66332A-09

S E R V I C E N O T E

Agilent 66332A DC Power Supply

On faster computers, when programming over GPIB, a random error will occur.

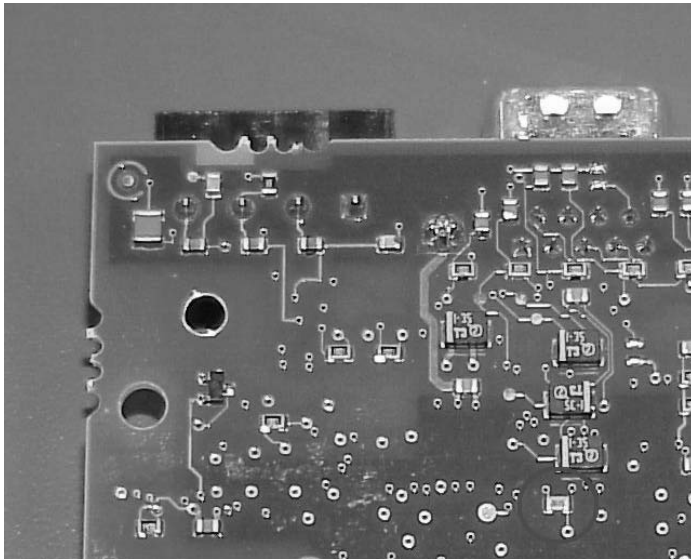
When programming a unit over GPIB, a random error -113 (“Undefined header”) will appear on the unit. This error can be read back via the front panel or over the GPIB bus.

Change resistor R1246 (see picture for location) from 511 Ohms to 100 Ohms (part number 0699-3058). This requires un-soldering and soldering a surface mount component and can be very difficult. This does not require re-calibration.

Replace the entire GPIB assembly (part number 5063-4841) with a newer one that has the 100 Ohm resistor. This will require the unit to be re-calibrated.
